DESIGN COMMISSION REGULAR HYBRID MEETING AGENDA

3. DCB25-02: Design Standard Review (DSR) 25-002 Study Session – Extra Mile

4. DCB25-03: Design Standard Review (DSR) 25-003 Study Session – Encounter Church

STAFF REPORT DESIGN COMMISSION STUDY SESSION

E01 FACE / HALO LIT CHANNEL LETTERS ON PANEL **26-PC**

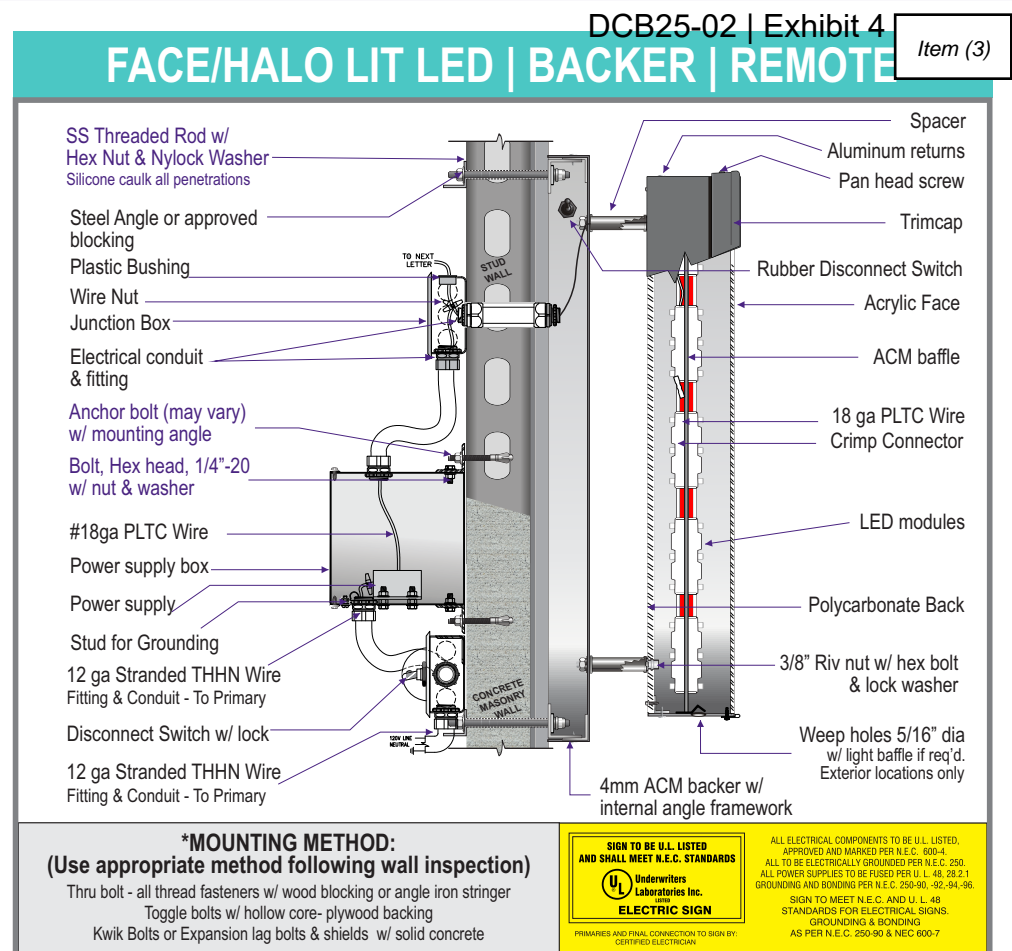
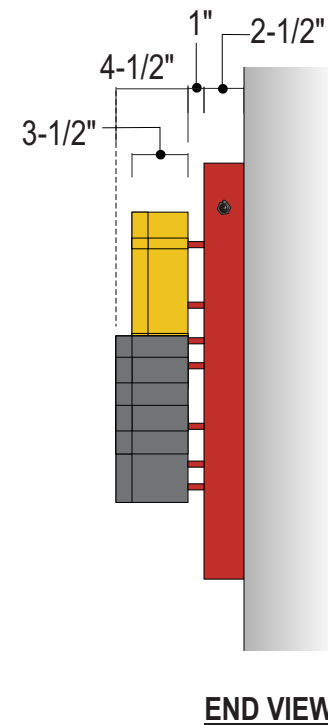
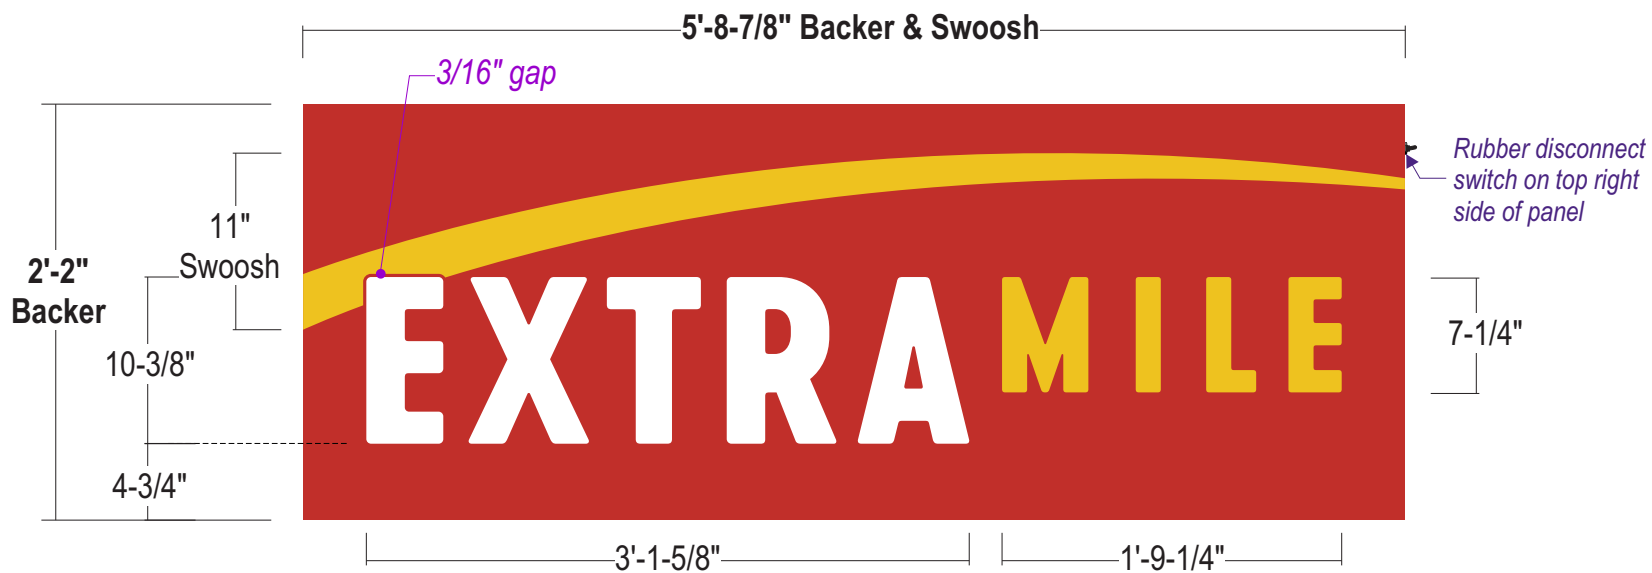
1. Applicant questions:
 - i. All scope shown can be covered under one building permit. Scope which does not require a building permit can be performed following land use approval, if applicable. See MICC 17.14.010 Section 105.2 for exceptions to building permit requirements
 - ii. All scope shown can be covered under one building permit. Replacement of illuminated panels in existing enclosures does not require a building permit. A new attachment of signage to structure, or the construction of a freestanding sign does require a building permit.
 - iii. Electrical permits which do not require plan review can be applied for and self-issued at mybuildingpermit.com.
2. The most common plan review comment that delays issuance of building permits for this type of work is a lack of information on the structural substrate to which the sign is
